Natural Resources Wales Technical Review Of Landfill Gas Management Systems

12th November 2013

Permit No: EAWML37207

Brookhill Landfill Gas Review and Methane Emissions Survey

Figure 1 Brookhill Gassim Model

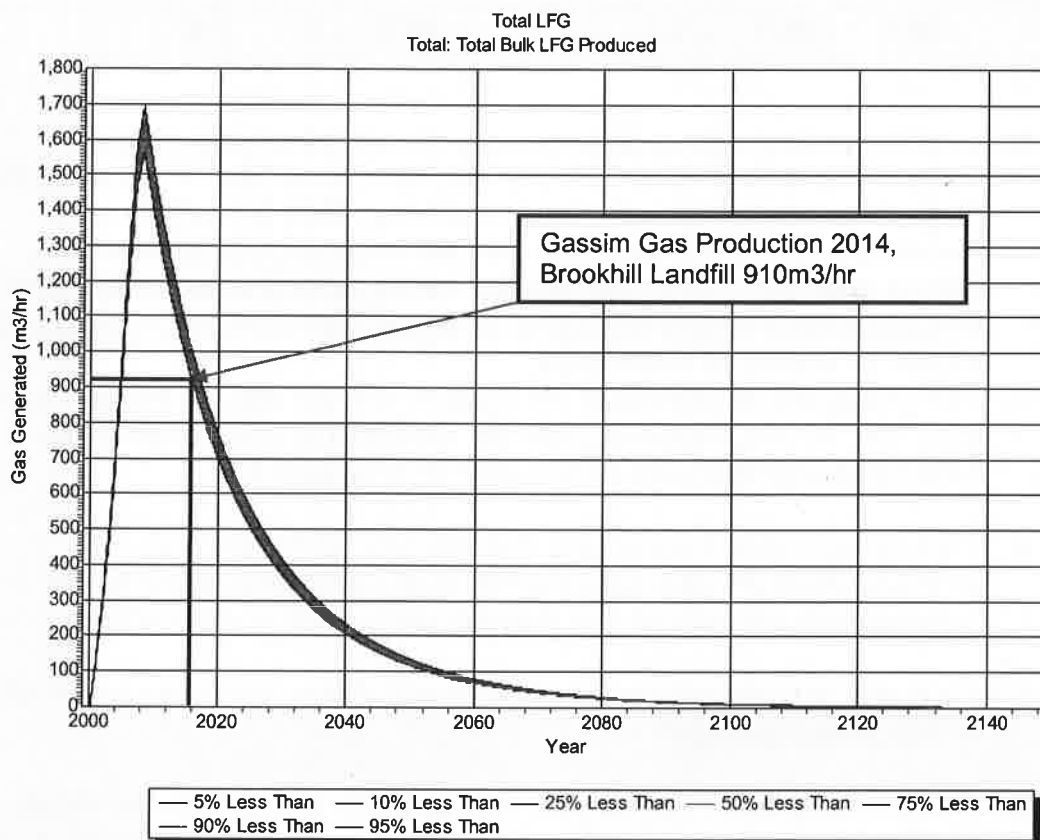
Figure 1 below shows the bulk gas generation curve produced using the Operator's data in Gassim, NRW's preferred gas production modelling tool. The modelled waste input is around 1.5 million tonnes of HCl waste (composition being around 60% domestic, 40% commercial so it is very biodegradable). The main issues are numbered as follows;

1. The moisture content is run 'Average' rather than 'Wet'. This may mean that the gas production rate has been underestimated as all of North Wales is designated as wet or super wet as far as Gassim modelling is concerned. We do recognise however that the site has been capped for some time.
2. The site has accepted a total of approximately 1.5 million tonnes of waste. At a range of 6m³-10m³, of gas/tonne per year this equates to 1027m³/hr-1712m³/hr at this point in time. The lower of these figures is 117m³/hr more than the Gassim estimate of 910m³/hr. For the sake of circumspection the lowest figure has been used for calculation of extraction efficiency.

3. The gas extraction rate at the site on the day of the audit was 420m³/hr @ 50% CH₄ (see results table below). This means extraction efficiency at the site is likely to be in the order of 46%. Using the lower figure in Gassim (run average for moisture content).

4. This extraction efficiency is unacceptable at a capped landfill of this nature with relatively recently tipped active waste. Reference LFTGNO3 (Landfill Technical Guidance Note) which recommends a target efficiency of 85%.

5. Taking 85% of the total Gassim estimate for gas production at this time would give a gas collection rate of 774 m³/hr a deficit of 353m³/hr.
6. The findings of the audit concur with the serious under extraction of gas at the site as demonstrated above, this situation must be remediated quickly in order to comply with the requirements of the Landfill Directive and the Welsh Governments Climate Change Programme.
